Sydney Metro Martin Place

North Tower Base Building Changes

SSD/ MOD drawings & FC2 Comparison

Rev #02 – 26/10/21

Level 12 Plan

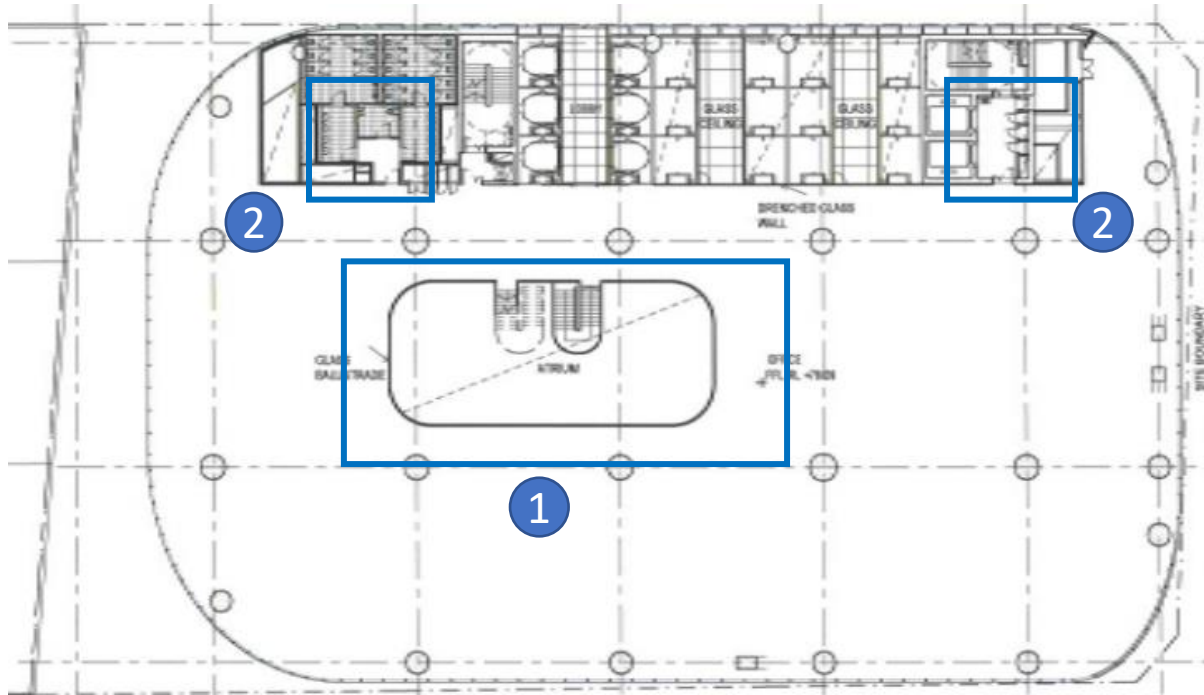
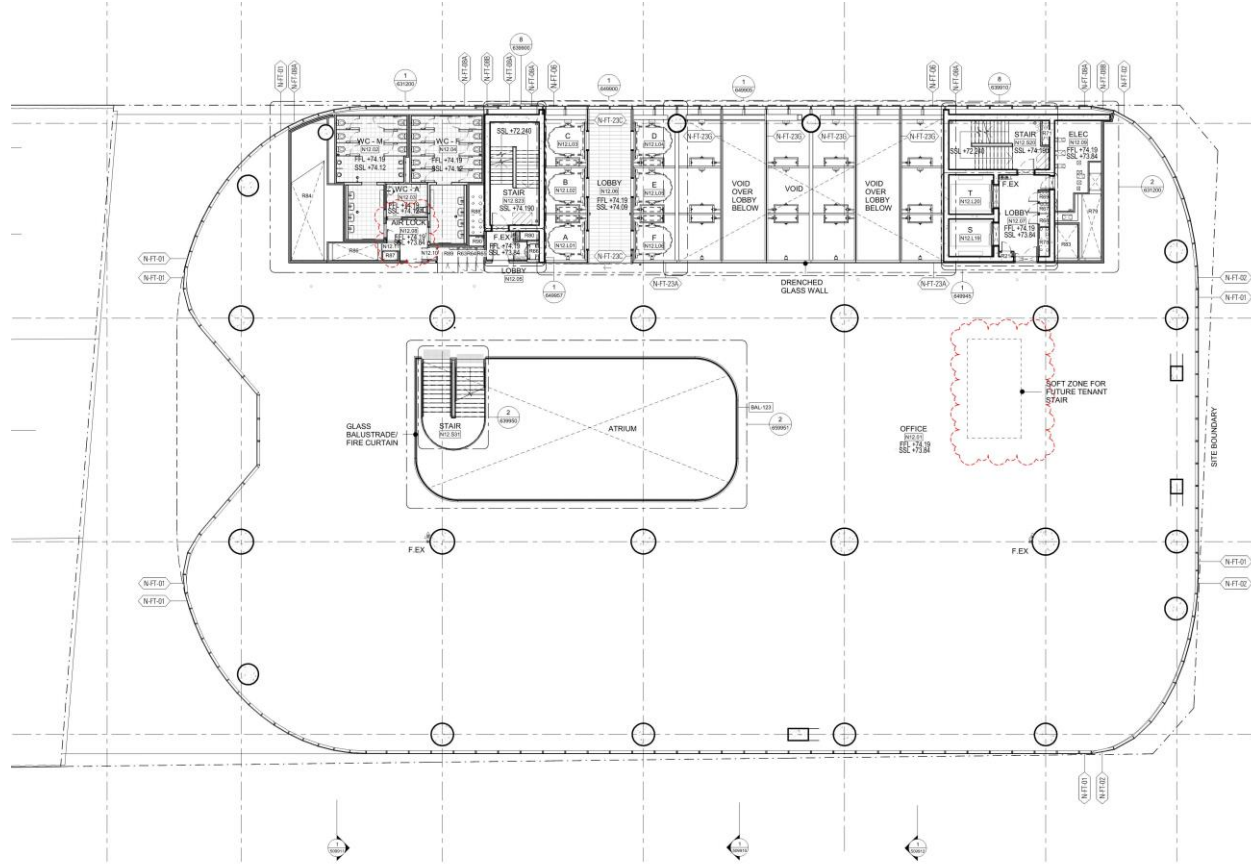
- 1.Atrium and stair revised
- 2.BOH layout revised

Level 13 Plan

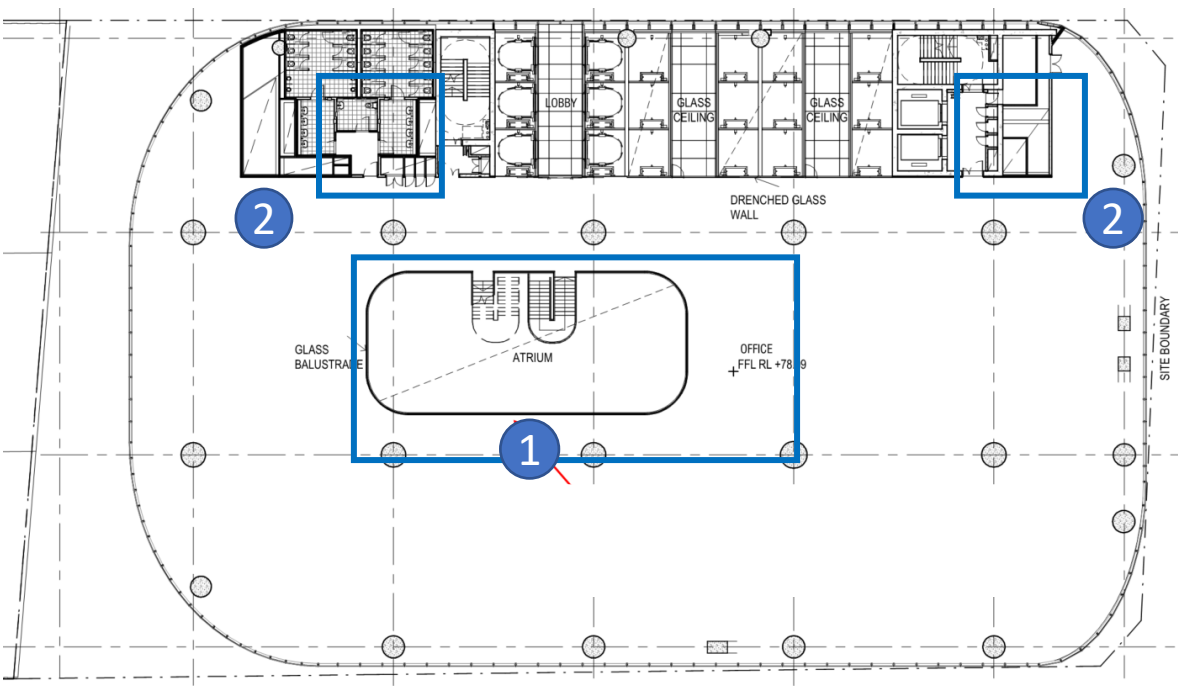
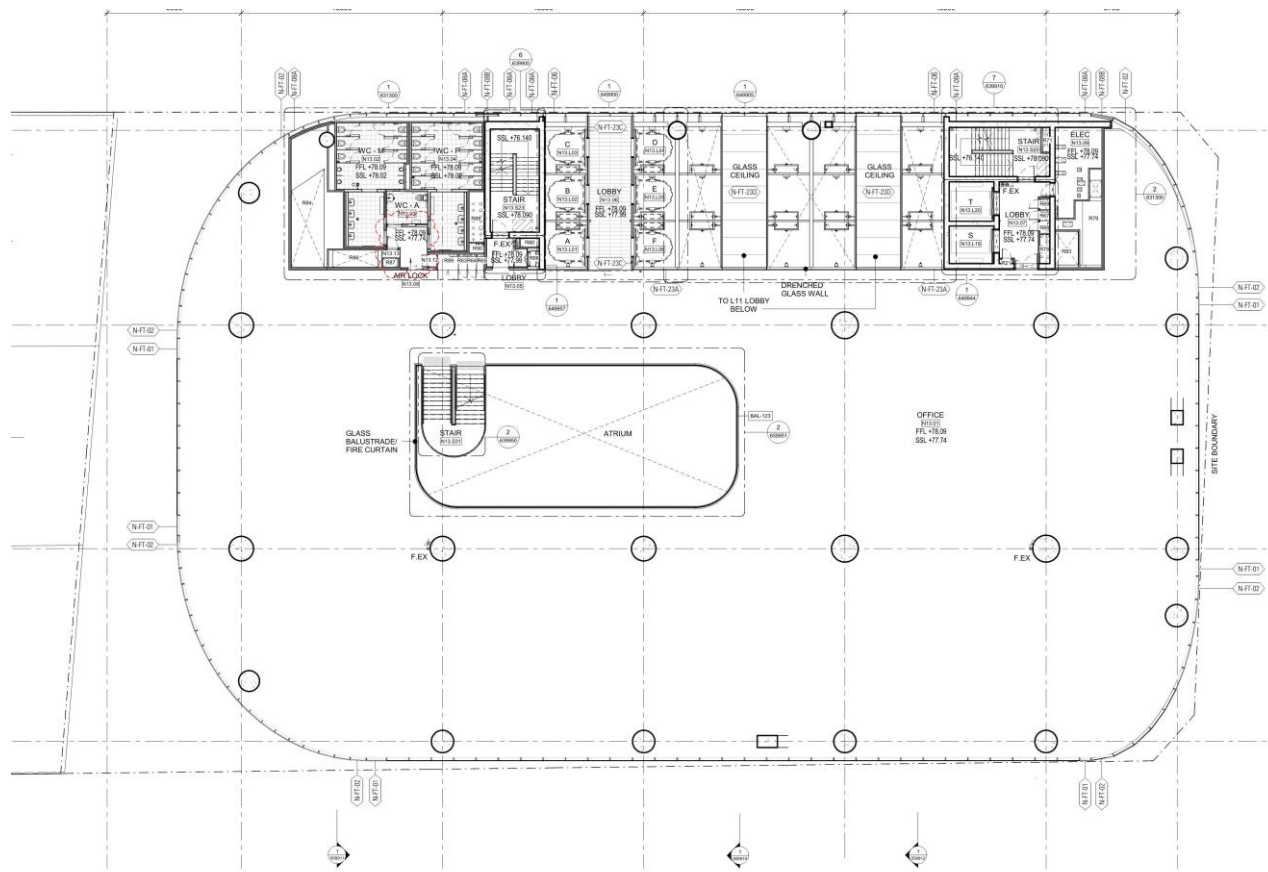
- 1.Atrium and stair revised
- 2.BOH layout revised

Level 14 Plan

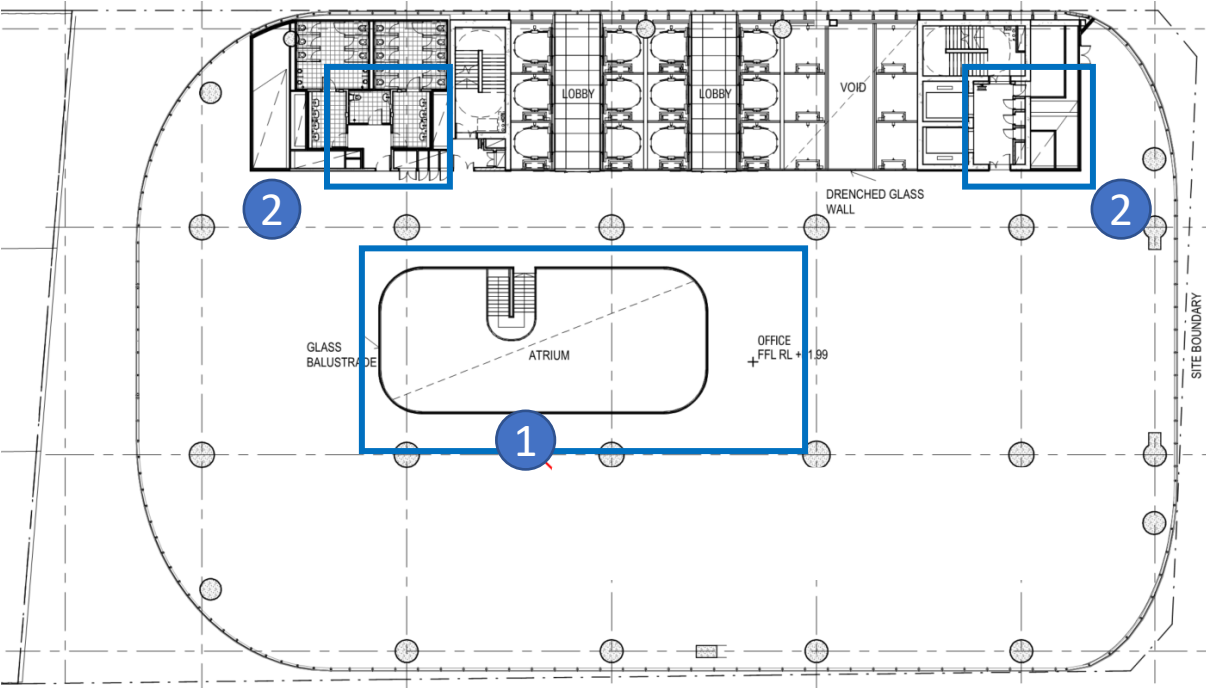
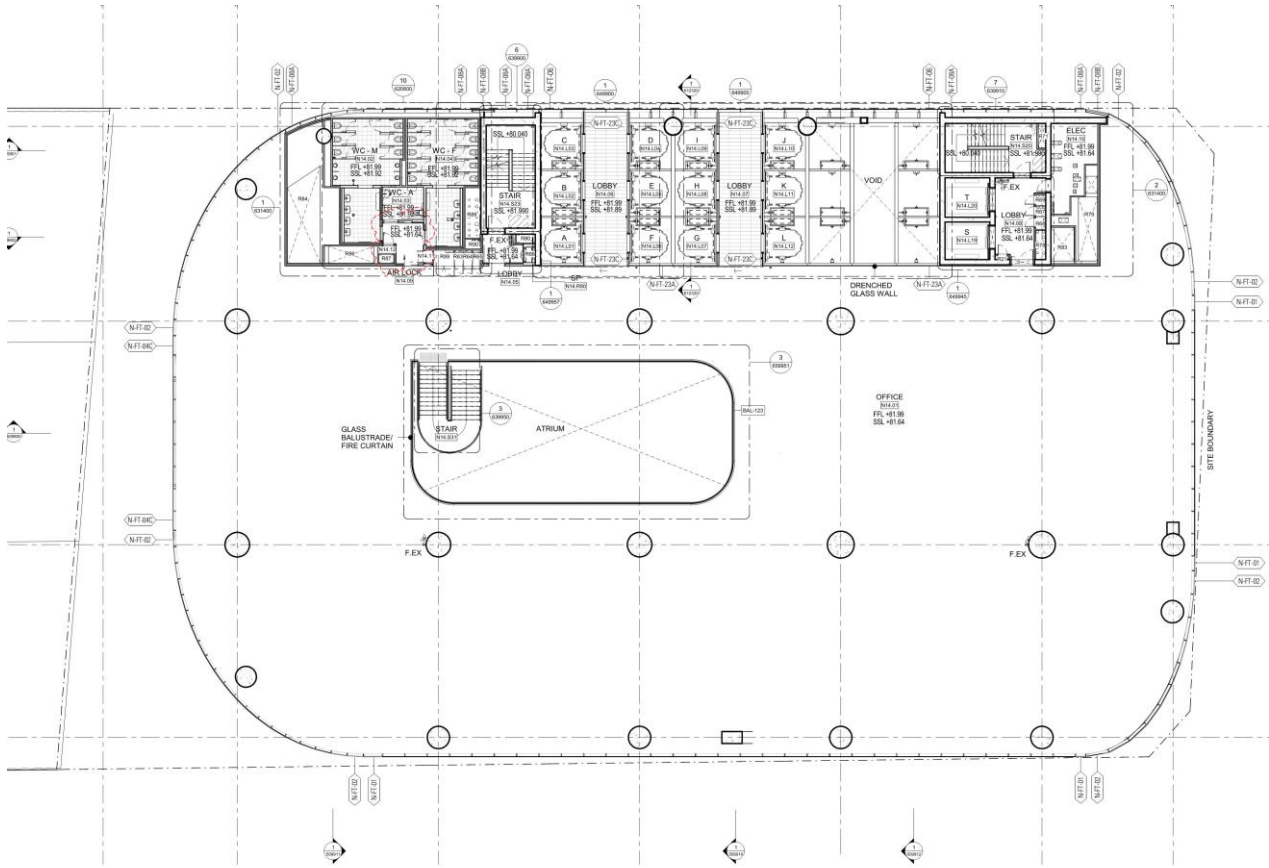
- 1.Atrium and stair revised
- 2.BOH layout revised

Level 15 Plan

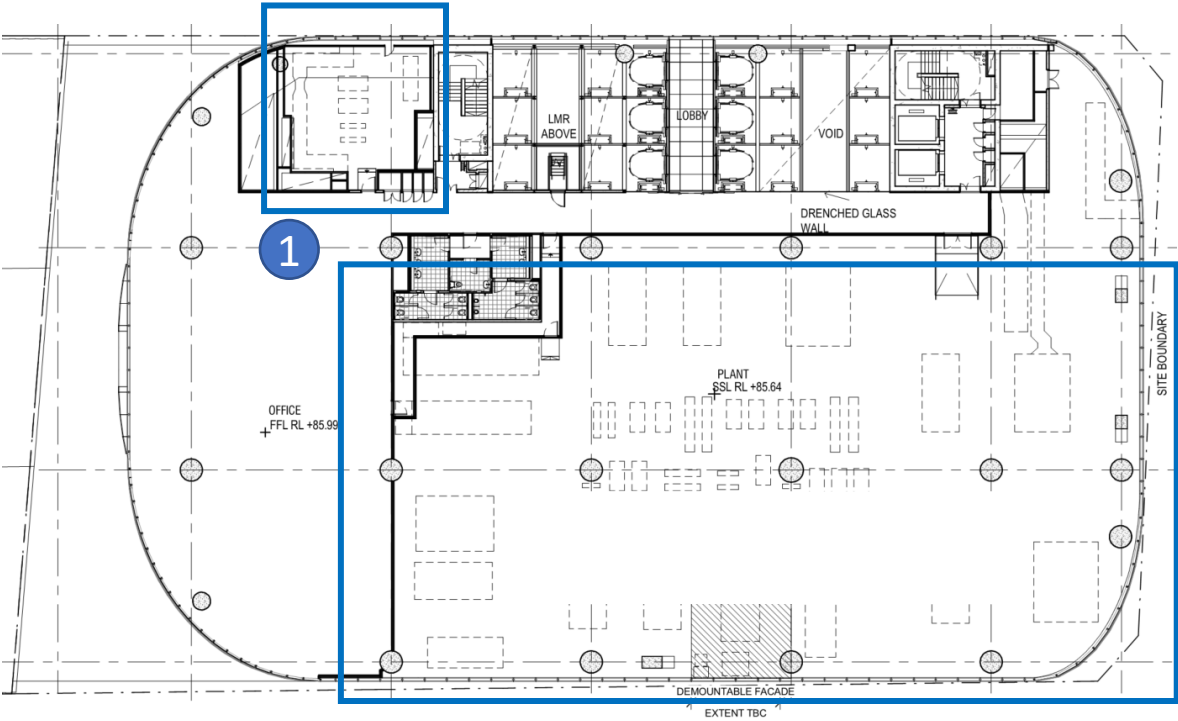
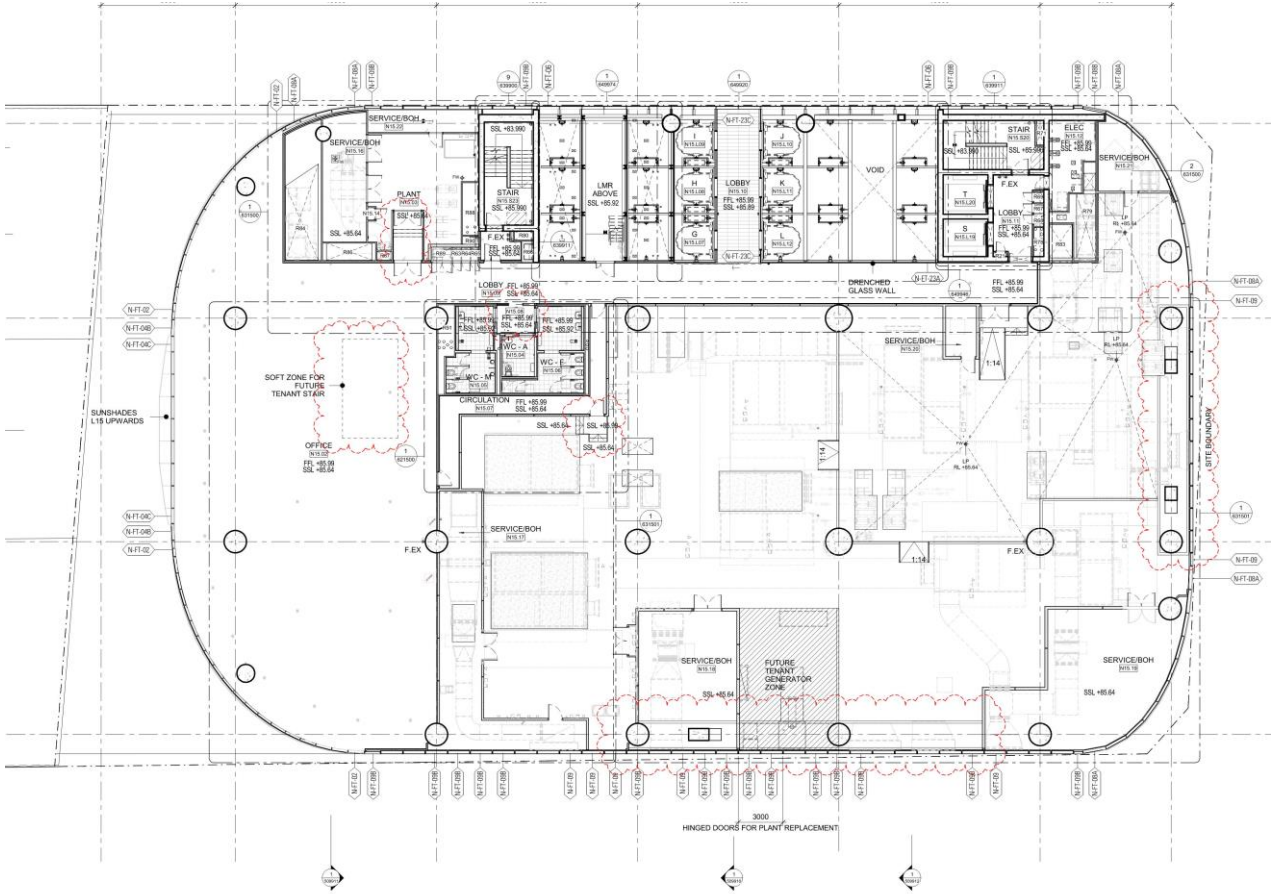
1.BOH layout revised

Level 16 Plan

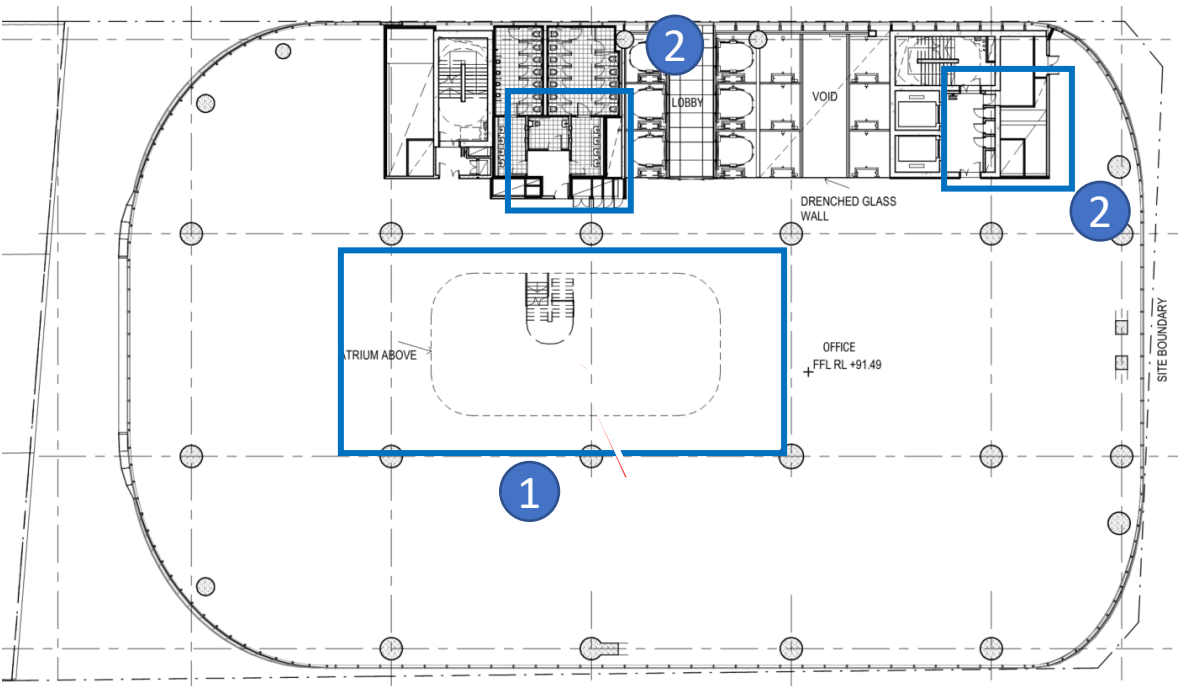
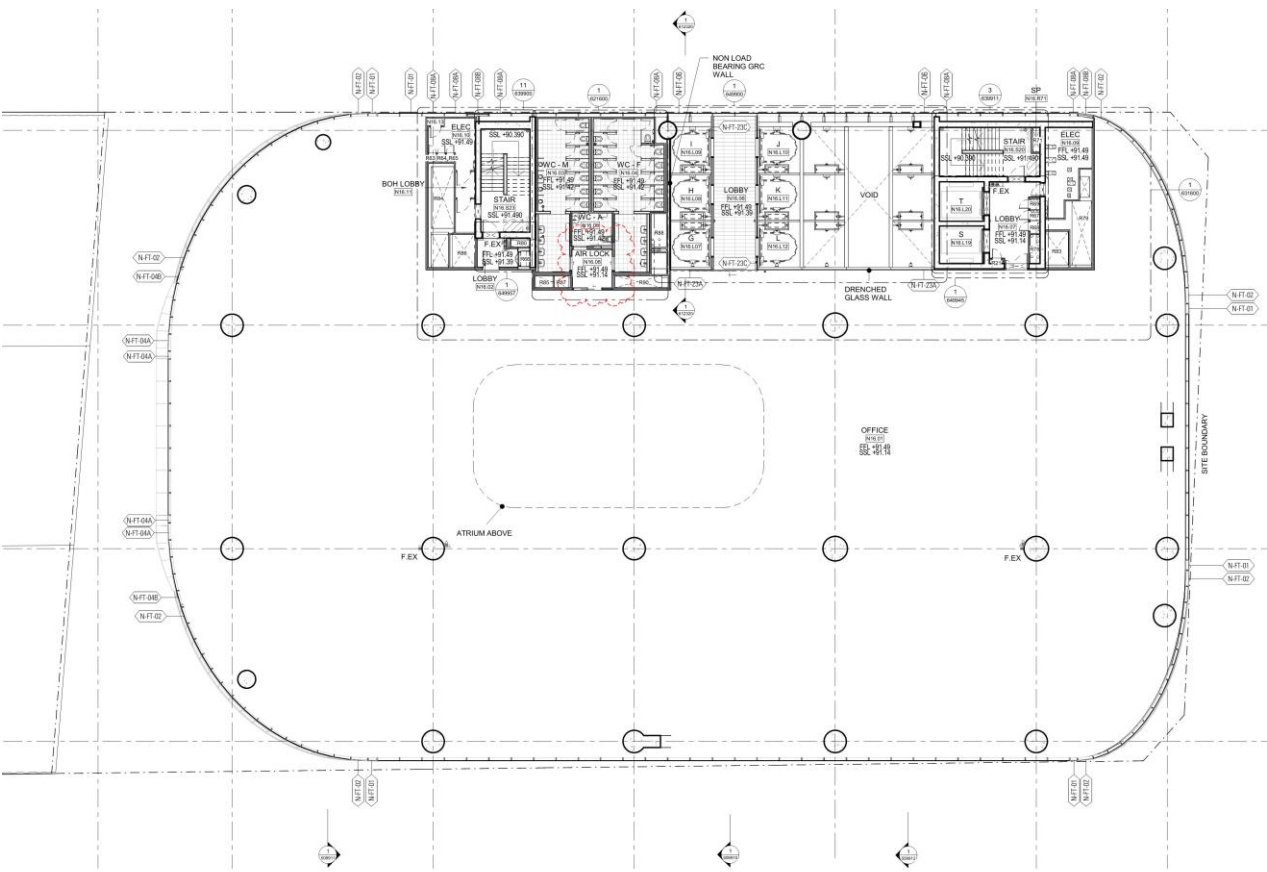
- 1.Atrium and stair revised
- 2.BOH layout revised

Level 17 Plan

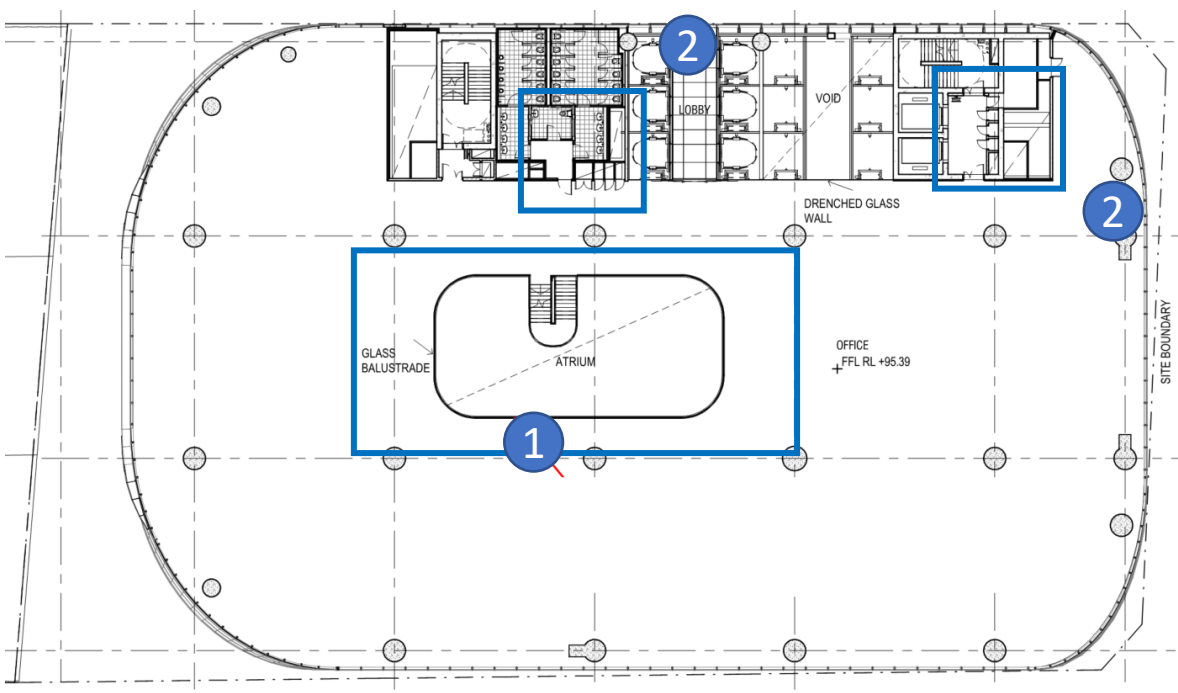
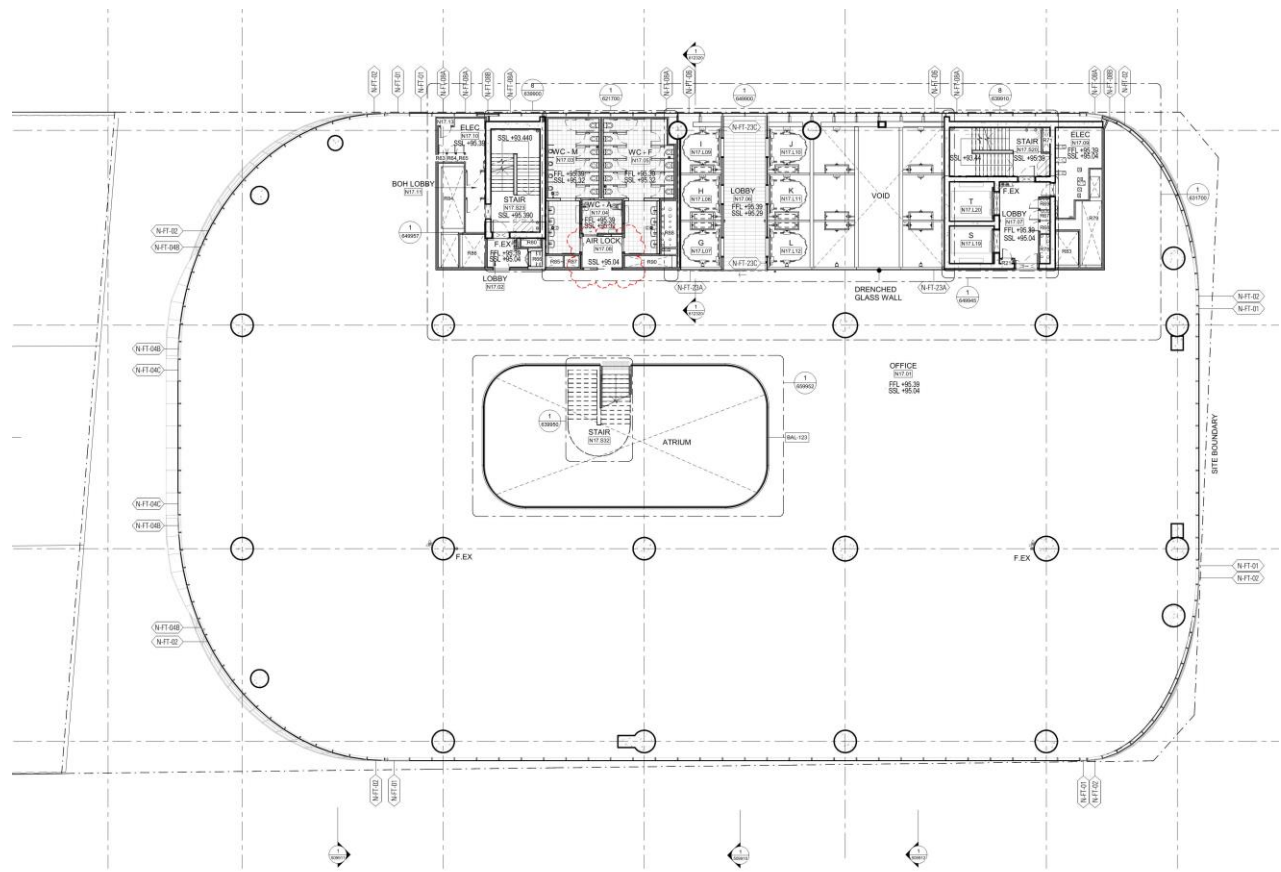
- 1.Atrium and stair revised
- 2.BOH layout revised
